ALERT SERVICE BULLETIN

412CF-21-71

MODEL AFFECTED: 412CF

SUBJECT: TAIL ROTOR DRIVE SHAFT ASSEMBLY 412-040-620-103 INSPECTION AND REMOVAL FROM SERVICE

Figure 1. Location of part and serial numbers

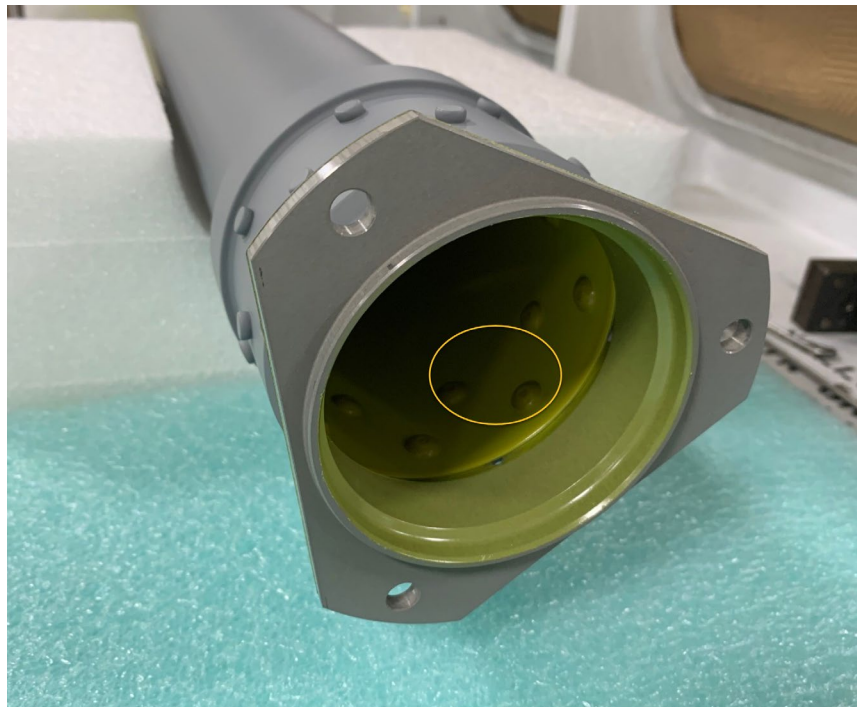
3. Verify the serial number of the tail rotor drive shaft assembly installed on the helicopter. The drive shaft assembly part number and serial number are located on the flange of the drive adapter attached to the intermediate gearbox (refer to Figure 1)

1) Do not confuse drive adapter 412-040-623-101 serial number with the drive shaft assembly 412-040-620-103 serial number.
4. If the drive shaft assembly serial number is not listed in the parts affected section of this bulletin, no further action is required. Make an entry in the helicopter logbook and historical service records indicating findings and compliance with this Alert Service Bulletin.
